System Impact Assessment Report (Addendum)

Project: *Woodstock Area Transmission Reinforcement*

Applicant: Hydro One Networks Inc.

CAA ID 2006-253

Figure 2: New Proposed Woodstock Area Transmission Reinforcement

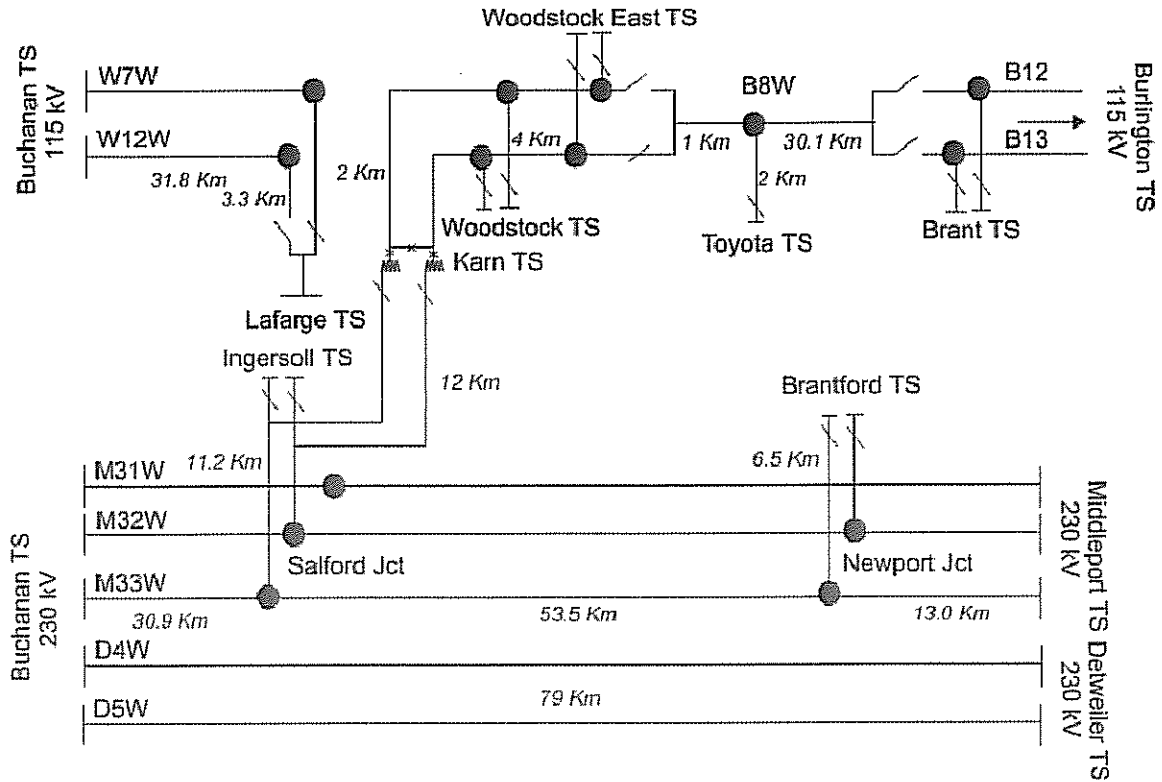
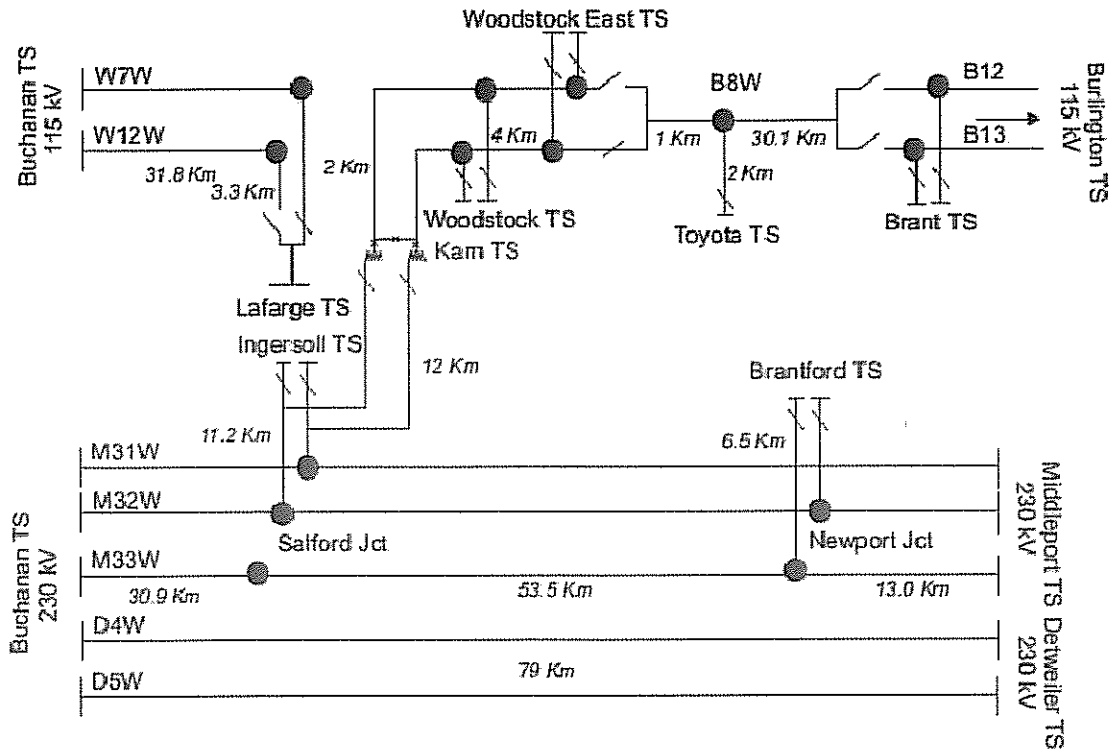
The proposed Woodstock Transmission Reinforcement System Impact Assessment was completed (CAA ID 2006 -253) on April 24, 2007. Recently, Hydro One has submitted a modified design of the Woodstock Transmission Reinforcement to the IESO. Because there is a significant protection issue caused by the emergency by-pass facilities located at Salford junction, modifications are proposed to reconfigure connection arrangements at Salford Junction so that the double circuit line from Salford to Ingersoll to Karn would be connected to M31W and M32W instead of M32W and M33W. A schematic diagram reflecting the proposed changes is shown in Figure 2. In addition, in order to simplify the protection design for the Woodstock Transmission Reinforcement project, Hydro One would like to remove the M31W-Q30M tie.

The M31W-Q30M tie was temporarily built as a backup 25Hz supply to the Allanburg area about 20 years ago and has never been used. It is acceptable to remove the M31W-Q30M tie to reduce the complexity of the protection design for the Woodstock Area Transmission Reinforcement project.

This System Impact Assessment concludes that the modifications to the Woodstock Transmission Reinforcement are not expected to have a material adverse effect on the IESO-controlled grid. Study results show there is no significant difference from the original connection arrangements. The IESO requirements for the connection of the proposed Woodstock Area Transmission Reinforcement in the SIA report, issued on April 24, 2007, remain valid.
